I object to the Bowden's Mine Project near Lue. The potential impacts of this project are wide-ranging however I have focussed only on a few key areas. These include the project's proximity to Lue, lead dust and suppression issues, impacts to water as well as the permanent and toxic legacy this mine will leave in our area forever.

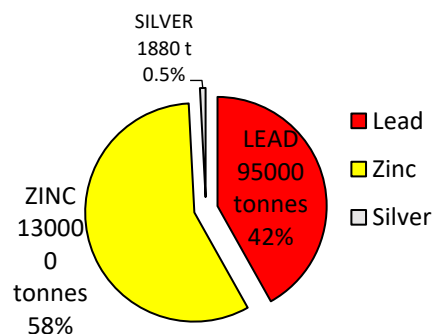
A major concern regarding the Bowden's project is its proximity to the village of Lue. Key distances include:¹

- Closest Activity (southern barrier) - 1.9km
- Main Open Cut Pit - 2.1km
- Primary Crusher - 2.9km
- Grinding Mill - 3.3km
- Tailings Storage Facility (TSF) - 1.9km

Lue may not be the largest community in the Mid Western Regional Council area, but it is important. It has enormous potential for growth and prosperity through existing industries such as agriculture, hospitality, accommodation and tourism. A mining operation at the scale that Bowden's proposes, should not be approved within such short distance of this village. As described in the Bowden's EIS, there is a *"need to operate the grinding and metal recovery components within the processing plant 24 hours per day, 7 days per week, whilst satisfying relevant noise criteria"*.² I am concerned that the noise and dust impacts from constant operations will lead to a reduction in people's desire to live in and interact with Lue, and as such result in a downturn in the activity in the town, and negatively affect property values.

It is unlikely this project would have ever progressed this far had it been positioned within 2 kilometres of a more heavily populated town like Mudgee, Rylstone or Gulgong. Other nearby examples of town decay as a result of mines in close proximity include Ulan and Wollar.
